TECHNICAL EVALUATION OF THE  
DETAILED CONTROL ROOM DESIGN REVIEW  
FOR  
WISCONSIN PUBLIC SERVICE CORPORATION'S  
KEWAUNEE NUCLEAR POWER PLANT

April 9, 1986

U.S. Nuclear Regulatory Commission  
Washington, D.C. 20555

Science Applications International Corporation  
1710 Goodridge Drive  
McLean, Virginia 22102

Figure 1- Design Modification Process

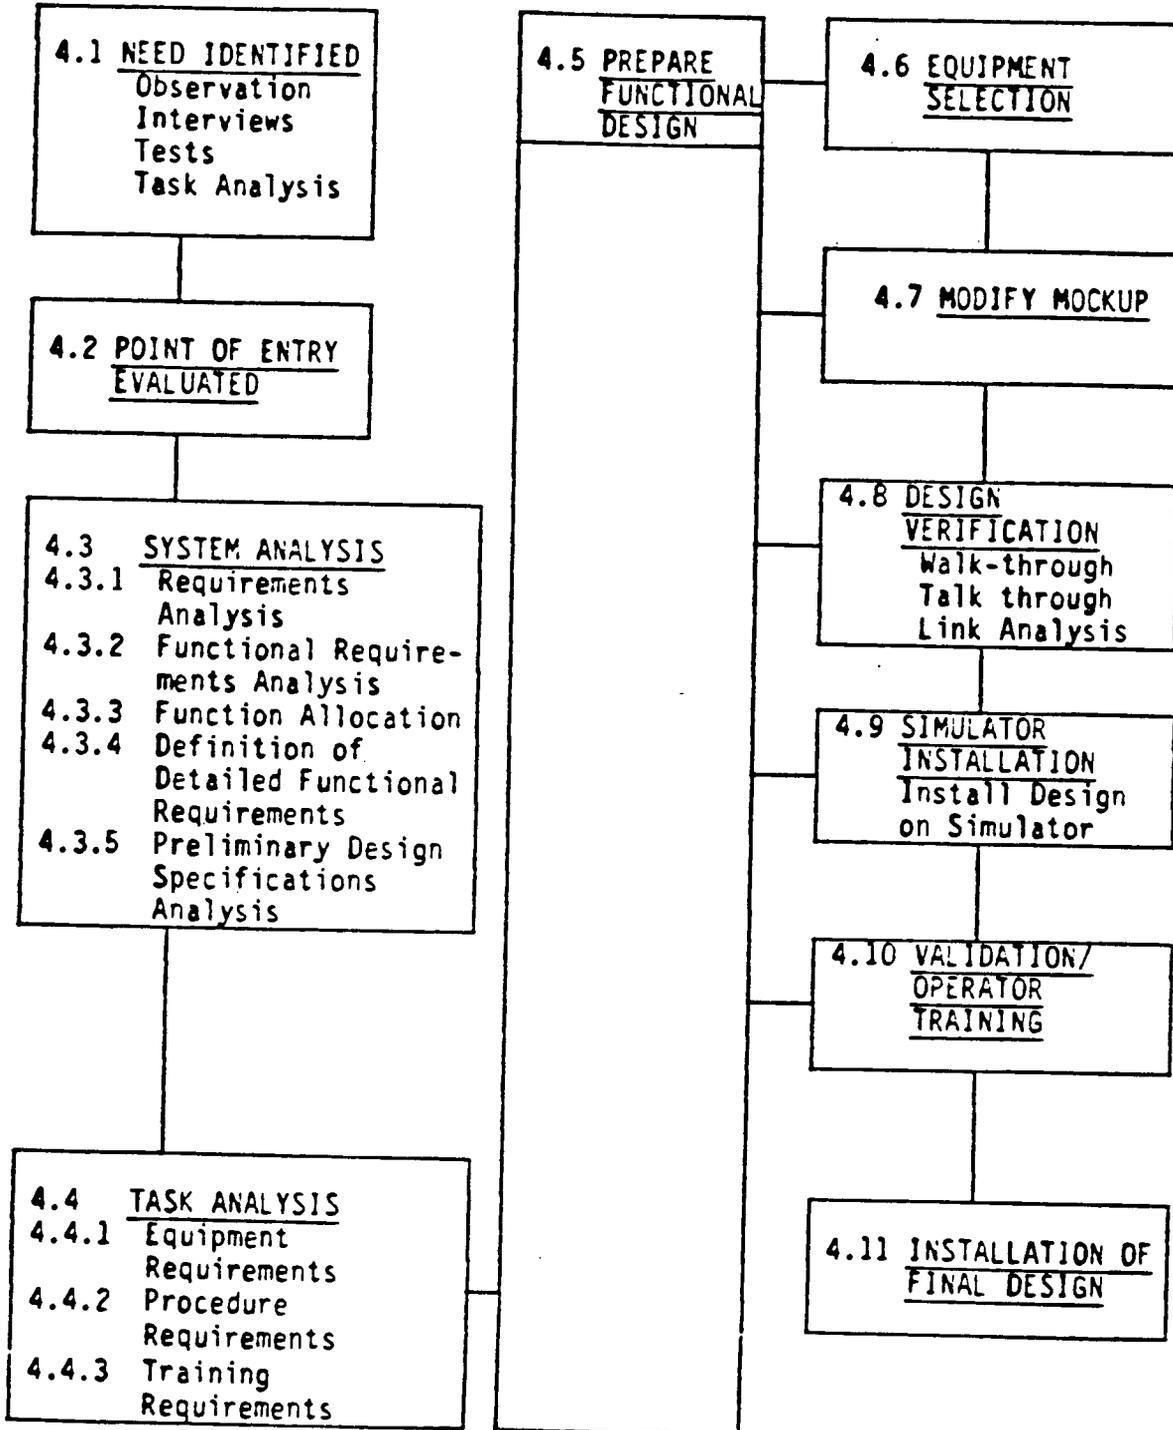
In order to address the NRC/SAIC concerns regarding the selection of design improvements, the licensee prepared a Human Engineering Review Process for Control Room Modifications flow chart (See Figure 1). This flow chart was presented by the DCRDR team to the NRC at the February 12, 1986, meeting (Reference 2). The steps in the design modification process are as follows:

Based on the licensee's description of the design improvement process, it is the reviewers' evaluation that the process and results should satisfy the requirements of Supplement 1 to NUREG-0737. But, two important pieces of documentation will be needed to meet the Supplement 1 to NUREG-0737 requirement. The supplement to the Summary Report should document the selection of the design improvement process described in the February 12, 1986, meeting. Second, the supplement to the Summary Report should outline the proposed control room change commitments, including their schedules for implementation. This second item is essential to satisfying the documentation requirements of Supplement 1 to NUREG-0737.

In an effort to resolve this concern, the licensee presented a "draft" flow chart and description of the verification process at the February 12, 1986, meeting (Reference 2). The Design Modification Process flow chart (see Figure 1) illustrates the process that will be followed to verify that the modification corrects the HED and does not introduce new HEDs. This flow chart will be part of Engineering Control Procedure No. 4.2, "Human Engineering Review Process for Control Room Modifications." The verification process, as described by the licensee and illustrated in the flow

The coordination of the DCRDR with training is illustrated in the Engineering Control Procedure for Human Engineering Review Process for Control Room Modifications (Reference 2), see Figure 1 in this report. As part of the licensee's design modification process, the training requirements for modifications are defined along with equipment requirements and procedure requirements. The actual operator training on the modifications is implemented during the Validation/Operator Training step in the design modification process. Based on this information, it is the reviewers' evaluation that operator training is appropriately integrated into the DCRDR.

In summary, the verification processes outlined in draft form should meet the requirement of Supplement 1 to NUREG-0737. In order to meet the requirement, the licensee should provide the final Engineering Control Procedure 4.2 in the Supplement to the Summary Report.
